This paper describes at an in-depth technical level the development of a low-cost radiosonde built using standard off the shelve parts. The low-cost values of such a system is one novel point. The second is the potential to have several in the air at a time allowing a swarm approach to measurements in the troposphere. However the scientific reward of this is poorly demonstrated.

NightTime Average Profile During 2018/07/14 - 2018/07/18

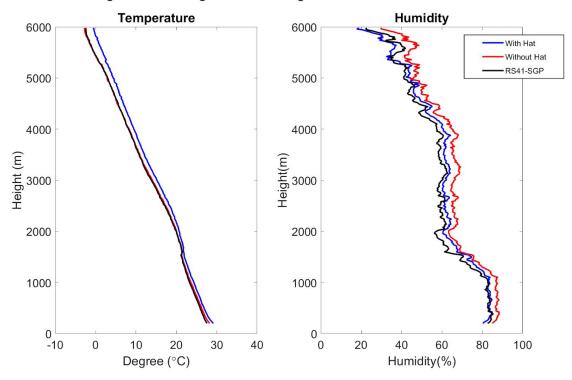
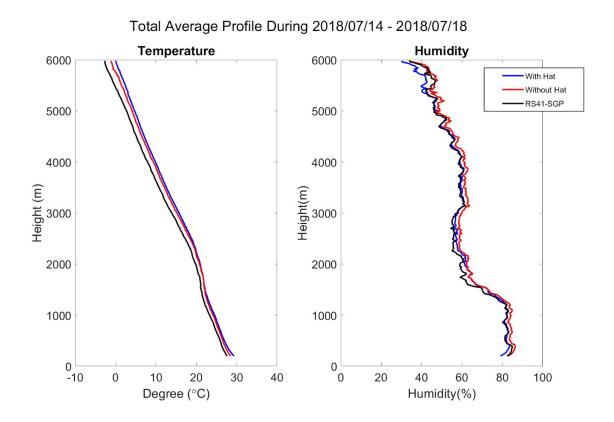
In Section 3 this can be better presented in terms of figures used. It appears the authors have got all the data they need to undertake a comprehensive comparison and they've missed the mark a bit. Firstly, I'd like to see a plot of vertical profiles of temperature and RH (Use RH and avoid Dewpoint as Dewpoint is derived from the RH on the RS41) from both the Storm tracker and RS41 on the same plot for day / night cases and with and without the protective screen. Avoid using a skew-T diagram as these are a function of pressure. Instead use the GPS height from both the storm tracker and RS41. They have similar Ublox systems within once you take the covers off.

Next, we now have all the Vaisala RS41-SGP and the Storm Tracker data at the same time coordinate. After calculating the means and standard deviations within the same height range, we show the vertical profiles of T and RH differences (Day, Night-time, and total) in the updated Figure 10. And the averaged measurements are shown in the following figures (Fig1,2,3).
